Enclosed you will find the Navy Responses to Regulator Comments on the Draft Technical Memorandum: Evaluation of Eastern Plume Extraction Well Network and Sites 1 and 3 Remedy, Naval Air Station (NAS) Brunswick, Maine. These RTCs are provided for your review and comment.

**RESPONSE TO COMMENTS FROM THE
STATE OF MAINE DEPARTMENT OF ENVIRONMENTAL PROTECTION –
BUREAU OF REMEDIATION AND WASTE MANAGEMENT
ON THE DRAFT TECHNICAL MEMORANDUM, EVALUATION OF EASTERN
PLUME EXTRACTION WELL NETWORK AND SITES 1 AND 3 REMEDY
NAVAL AIR STATION BRUNSWICK, MAINE**

Commentor: Claudia Sait, MEDEP - Project Manager-Federal Facilities Bureau of Remediation & Waste Management	
Comment Issue Date: 10 June 2009	Navy Response Date: 10 July 2009

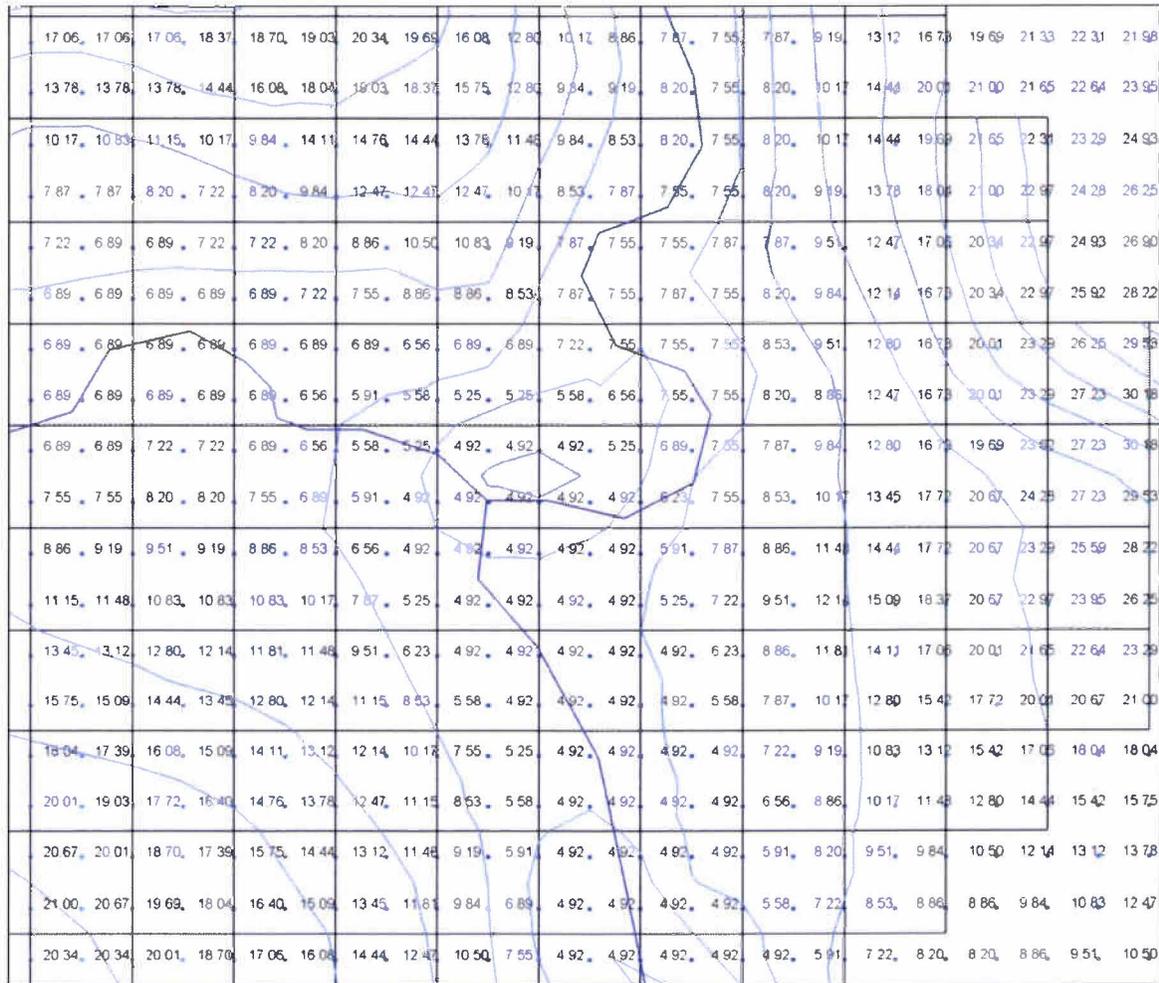
4. As noted in MEDEP's letter (January 22, 2009) on the Groundwater Modeling Summary Report the stream heads in the calibrated model show undulation in stream elevation. It is difficult to see in Figure E-3 (layer 1) which way the contour lines are going, but there are some suspicious points. The process of obtaining stream elevations from Digital Elevation Models (DEMs) in GMS can result in values that do not consistently decrease. The response to comment discusses flow field depressions in layers 3 and 5 and explains the depressions as a result of layer thinning. However MEDEP is mostly concerned about the stream elevations themselves, which must be addressed to minimize impacts to the model.

Response: The DEM file on which stream stage elevations were based was checked and is shown in the graphic below. The graphic shows the confluence area and specifically shows: the DEM points with their elevations; the "undulation" in simulated contours in the confluence area for model layer 2; the model grid; and the stream outline. As shown in the graphic, the DEM

points appear to consistently decrease over the length of the “undulation”. We maintain that the “undulations” are a result of the changing thickness of model layers as described in Response to MEDEP Comment 14 on the Groundwater Modeling Summary Report.
